ADDENDUM NO: 1

PROJECT: Clarksville Community Schools Interior Improvements

PROJECT NO: 2025014

DATE: 08/15/2025

DRAWING NUMBER
A901

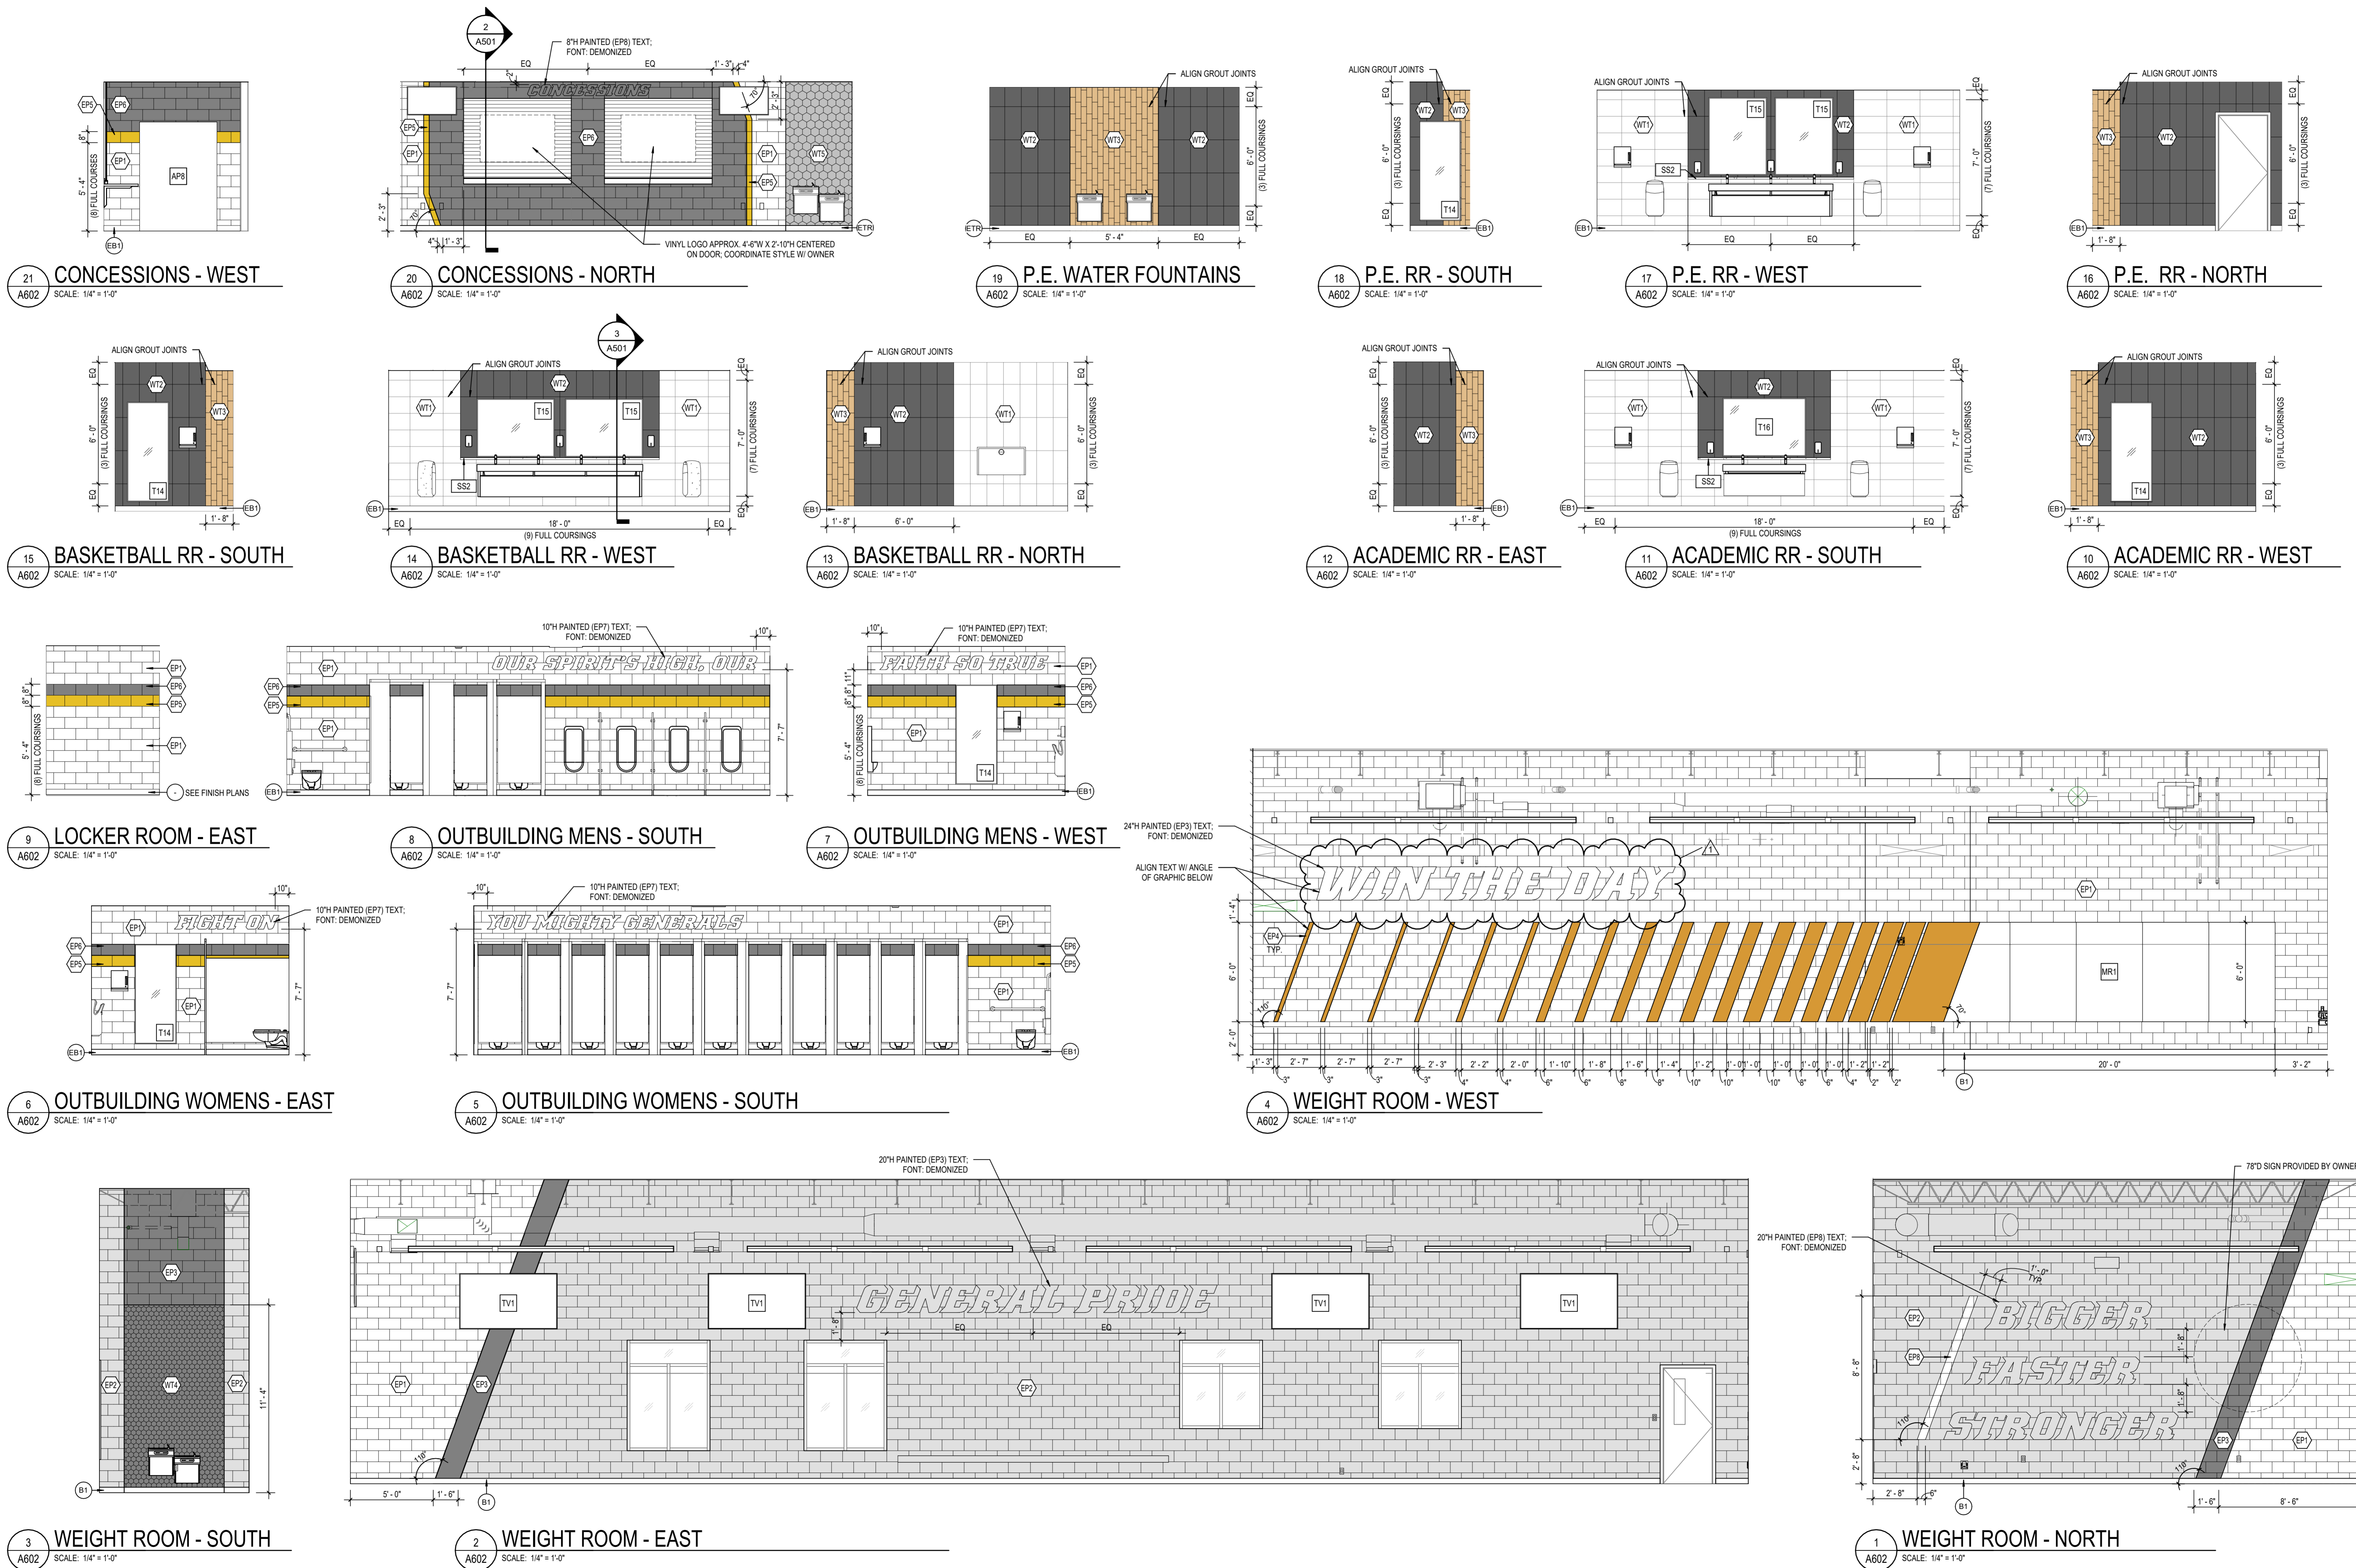
- A. **Add 5/A901** Closet Rod and Shelf detail to drawings and provide additional dimensions to plan for clarification.
